Project	IEEE 802.16 Broadband Wireless Access Working Group < http://ieee802.org/16 >	
Title	Informative description of network architecture	
Date Submitted	2005-01-24	
Source(s)	Duke Dang, Zhibin Lin, Lucy Chen HUAWEI HuaWei Bld., No.3 Xinxu Rd., Shang-Di Infomation Industry Base, Hai-Dian District Beijing P.R. China, 100085	Voice: 86-10-82882959 Fax: 86-21-82882966 mailto: dsjun@huawei.com
Re:	Contribution on comments to IEEE P802.16g baseline task group document	
Abstract	Add informative description of network architecture in P802.16g baseline document	
Purpose	Adoption	
Notice	This document has been prepared to assist IEEE 802.16. It is offered as a basis for discussion and is not binding on the contributing individual(s) or organization(s). The material in this document is subject to change in form and content after further study. The contributor(s) reserve(s) the right to add, amend or withdraw material contained herein.

Informative description of network architecture

Figure 1 Distributed network

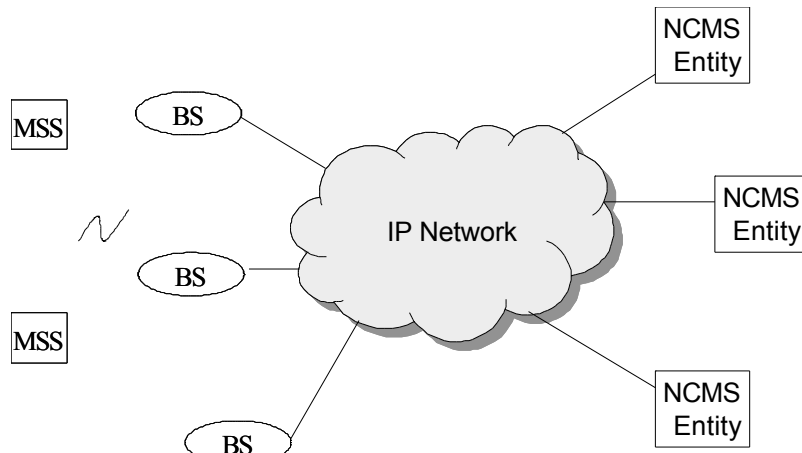
Figure 1 is a diagram of the typical full distributed network.

In a full distributed network, BS connects to IP network directly. NCMS is implemented as several network elements, each of the elements is also connects to IP network directly. Some NCMS functions, such as gateway and router service, are embedded in BS.

Figure 2 Centralized network

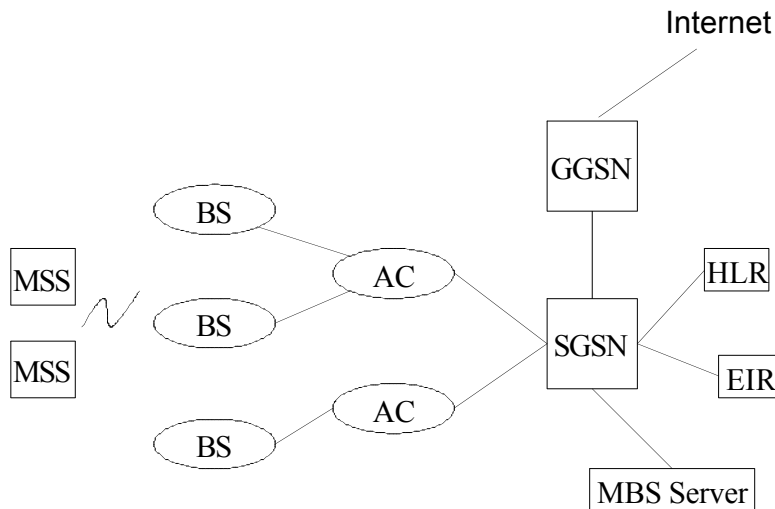
802.16's network can also be deployed as cellular system does now. Figure 2 is a diagram of the typical centralized network, which is similar to 3G core network.

In a centralized network, BS connects to IP network through AC, SGSN and GGSN.
